**CITY PLAN COMMISSION****THURSDAY, NOVEMBER 3, 2022****FILE NUMBER:** S223-004**SENIOR PLANNER:** Mohammad H. Bordbar**LOCATION:** Creek Drive at Oxford Drive, north corner**DATE FILED:** October 5, 2022**ZONING:** PD 765**PD LINK:** <https://dallascityhall.com/departments/city-attorney/Articles/PDF/Article%20765.pdf>**CITY COUNCIL DISTRICT:** 12      **SIZE OF REQUEST:** 7.828-acres      **MAPSCO:** 5C**APPLICANT/OWNER:** Plano Independent School District

**REQUEST:** An application to replat a 7.828-acre tract of land containing all of Lots 6 through 10 in City Block 1/8728, all of Lots 12 through 18 in City Block J/8728 and part of Lot 1A in City Block J/8728 to create one lot on property located on Creek Drive at Oxford Drive, north corner.

SCALE 1" = 50'  
DATE: SEPTEMBER 28, 2022  
ACR No. 2022-205 P.A.

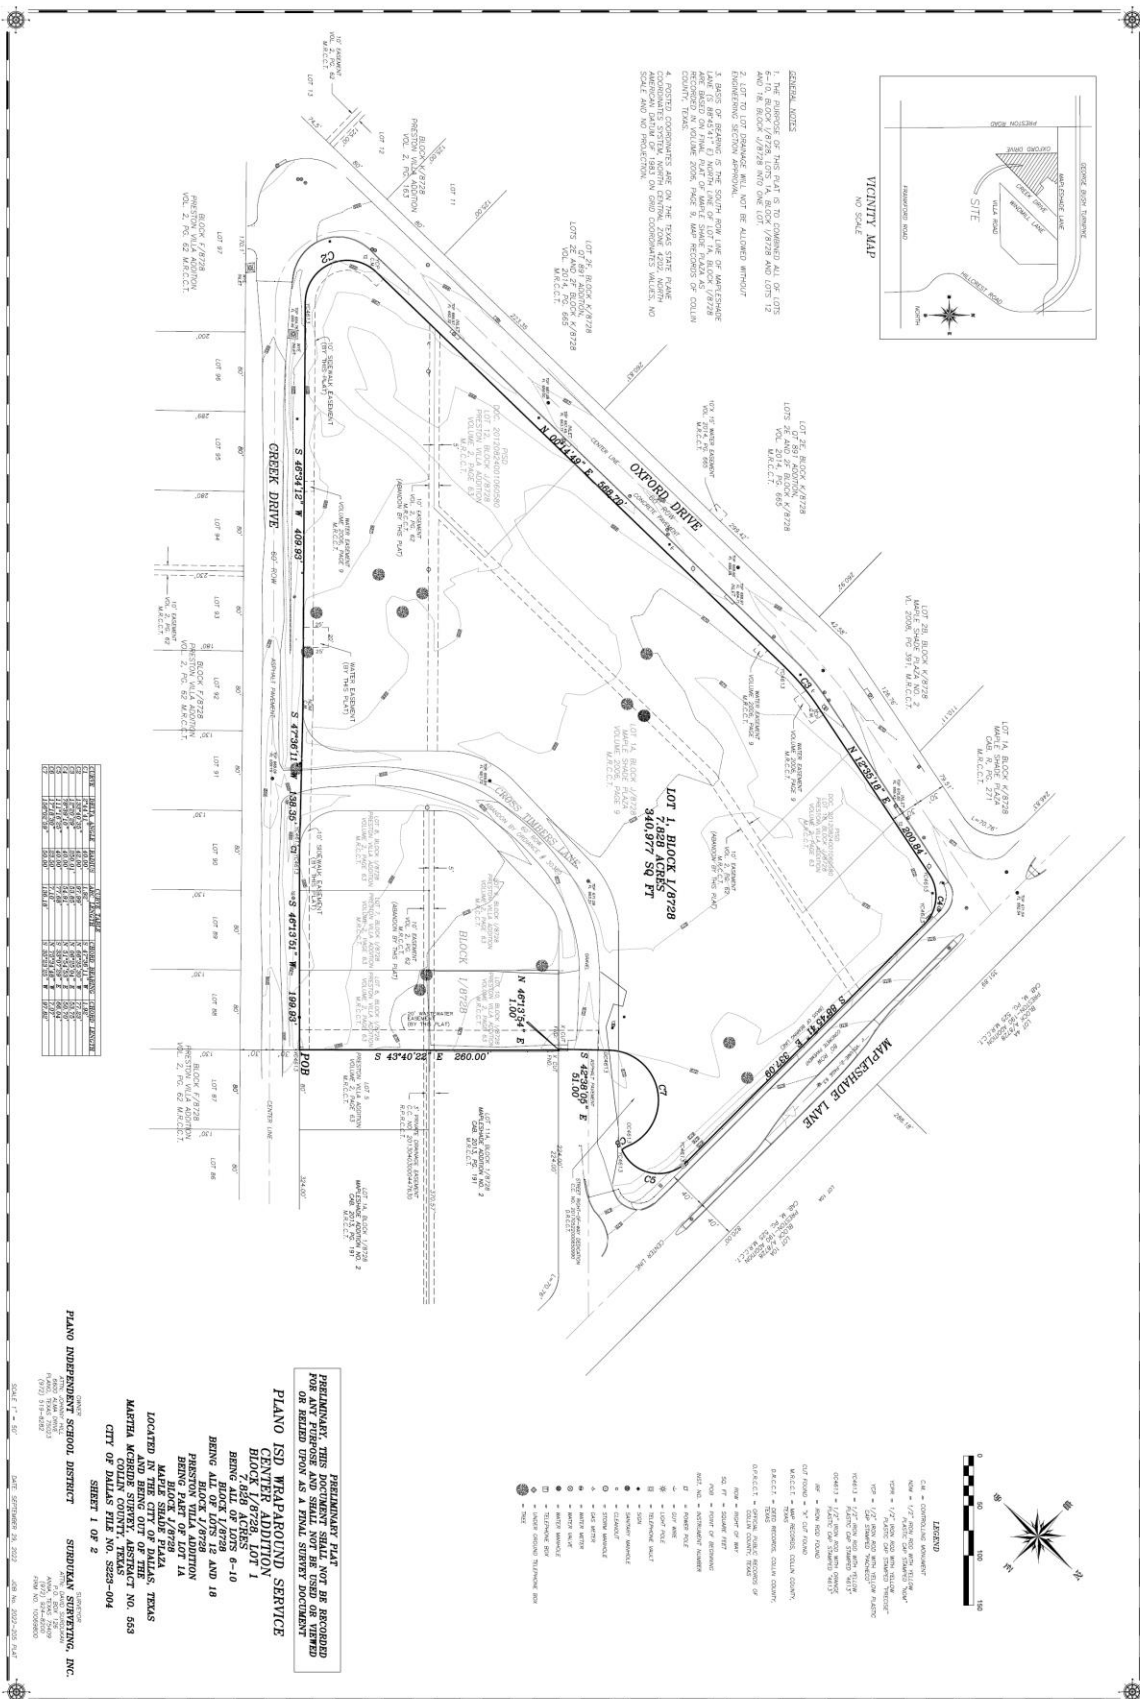
31. On the final plat, use standard language for 10'Easement abandonment noted on the plat as follows: "Abandonment authorized by Ordinance No.\_\_\_\_\_, recorded as Inst. No.\_\_\_\_\_. Contact Real Estate and advise if the language noted on the

plat 10' Sidewalk Easement, 20' Wastewater Easement and Water Easement by this plat is a dedication or an abandonment.

32. On the final plat, change "Mapleshade Lane" to "Mapleshade lane (F.K.A. Brandywine Lane)". Section 51A-8.403(a)(1)(A)(xii)
33. On the final plat, identify the property as Lot 1B in City Block J/8728. Ordinance 1A, Page 131 pages 131-148, Section 2 (passed August 13, 1872).
